ARCHITECTURAL REVIEW COMMITTEE
AGENDA REVISED
May 10, 2016
4:30 p.m.

ARCHITECTURAL REVIEW

Agenda Item: Accept the architectural plan as submitted for a four-tenant strip mall structure located at 7361 Glory Road.

Agenda Item: Accept the architectural plan with staff comments for a four-tenant strip mall structure located at 13499 Elmwood Drive.

3 PROPOSED WEST REAR ELEVATION (FACING ELDER DRIVE)
A3.1 1/16" = 1'-0"

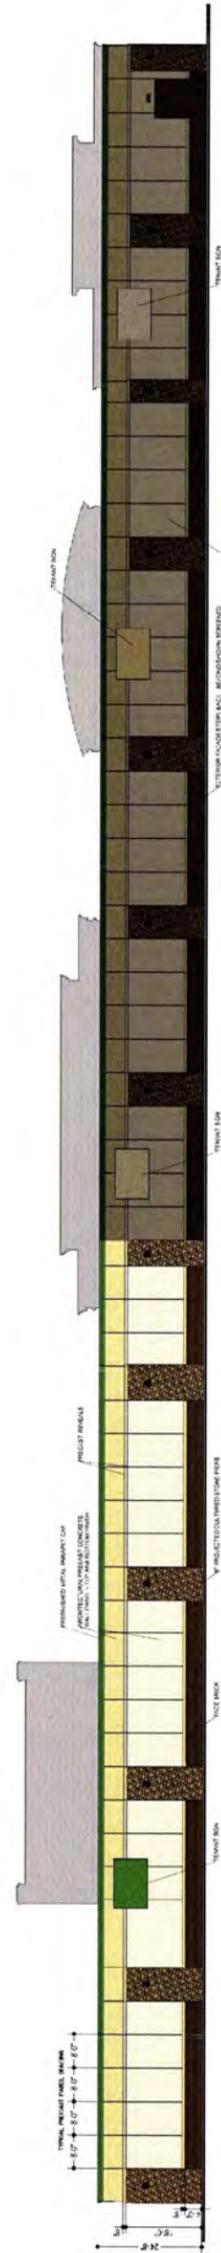
Exterior Materials	See allowed C-1 and C-2 materials	EIFS	OK
		Brick	OK
		Natural Stone	OK
		Architectural glass	OK
		Architectural precast concrete panels	OK
		Prefinished metal (maximum 10% accent material)	Requires recommendation by the Arc Commission and approval by the City Council.
Size/Mass	Proportional	Comparable to adjacent buildings	OK
Articulation – South/Side (facing JC Penny)	Max 50' Unbroken Expanse for faces >60' and facing street	40-feet wide, articulation provided with projecting stone piers	OK
	STAFF COMMENTS: A wing wall shall be added along Garrison Rd. for at least the length of a semi-truck and trailer to screen the Ulta loading dock from

the south. This wing wall shall have materials that match the building on both sides of the wing wall. Lastly, the applicant shall revise the site plan and floor plan to remove the comments that the wing walls are “loading dock retaining wall w/ 42” metal guard railing typ.” Staff requires wing walls at the full height of the building.		
Articulation – West/Rear (facing Elder Drive)	Max 50’ Unbroken Expanse for faces >60’ and facing street	40-foot wide, articulation provided with projecting stone piers	OK
	STAFF COMMENTS: The sporting goods store includes a parapet that is 18’4”. Staff is concerned about the extent of which the backs of the parapets would be visible from the back. Staff recommends that the ARC Commission consider a condition that the developer adds a parapet around the building to limit the view of the back of the parapet. At a minimum, the back of parapets shall include materials and color that match up with the west elevation.

2 PROPOSED NORTH SIDE ELEVATION (FACING COSTCO)
A3.1 1/16" = 1'-0"

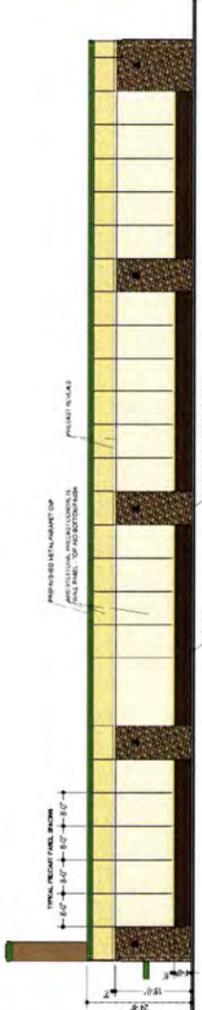
Articulation – North/Side (facing Costeo)	Max 50’ Unbroken Expanse for faces >60’ and facing street	48-foot wide, articulation provided with projecting stone piers and EIFS colonnades	OK
	STAFF COMMENTS: Incorporate stone and concrete panel to the corner of Ulta to provide balance to the uniform materials of the building.		
Articulation – East/ Front (Facing 371)	Max 50’ Unbroken Expanse for faces >60’ and facing street	20-foot wide, articulation provided with projecting stone piers	OK
	STAFF COMMENTS: Incorporate stone and concrete panel to the corner of Ulta to provide balance to the uniform materials of the building.		
Accessory Structures	Existing building coordinated color	N/A	N/A
Color	Earth tone	Brown, tan, beige, green Franchise colors	OK Unknown
	STAFF COMMENTS: It is unknown whether franchise colors meet the definition of earth tone colors. In addition, it is unknown if accent colors meet or exceed the 10% maximum requirement.

1 NORTH ELEVATION
A2.2 1/4" = 1'-0" (22x34)
1/8" = 1'-0" (11x17)

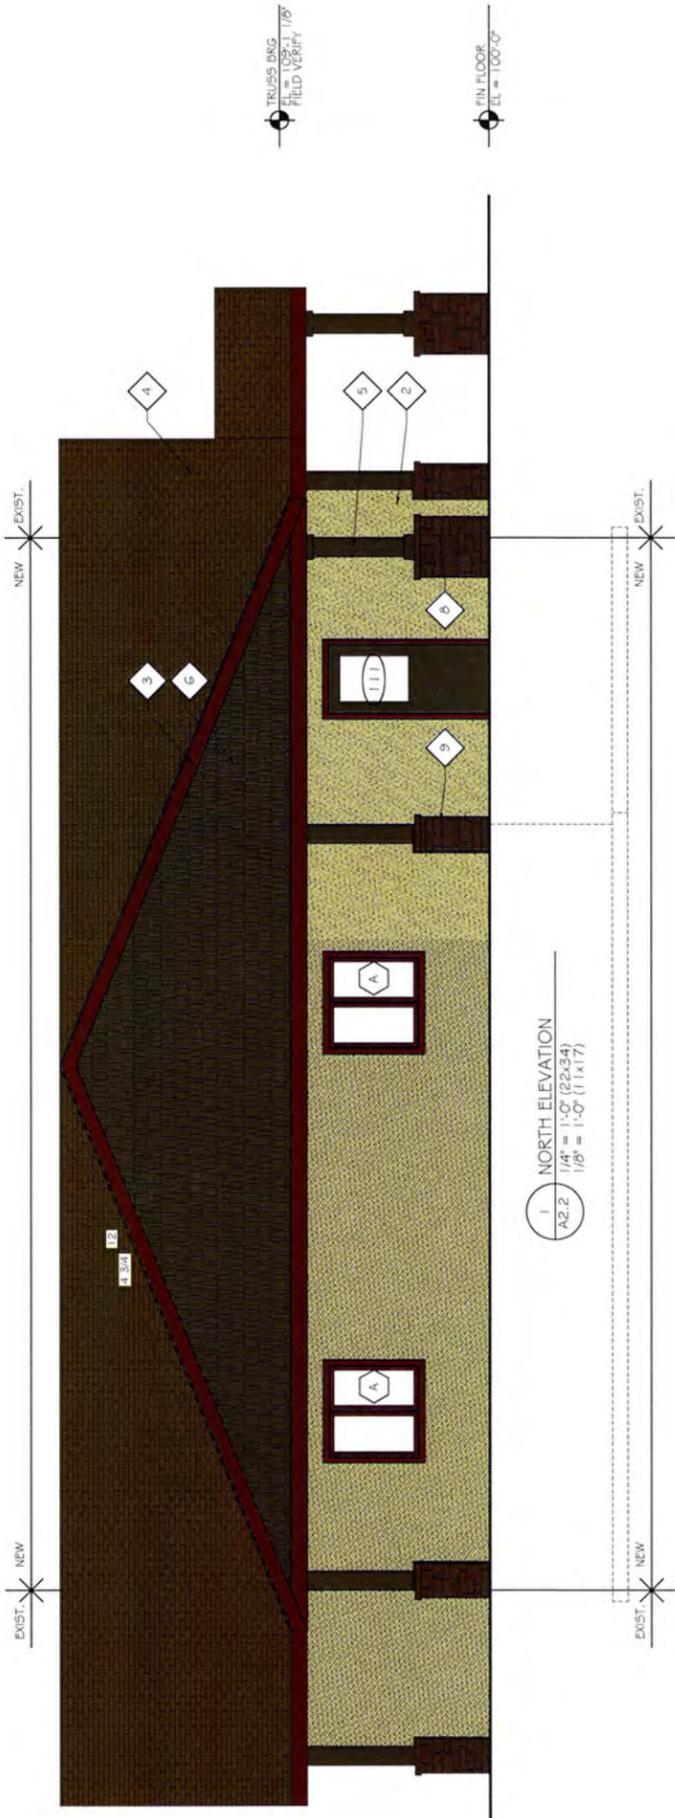
4 ¾:12 (north elevation)	ARC approval required

Staff recommends approval of the use of cement board shakes in the gables to match the existing structure and the incorporation of a 4 ¾:12 pitch roof on the north elevation.
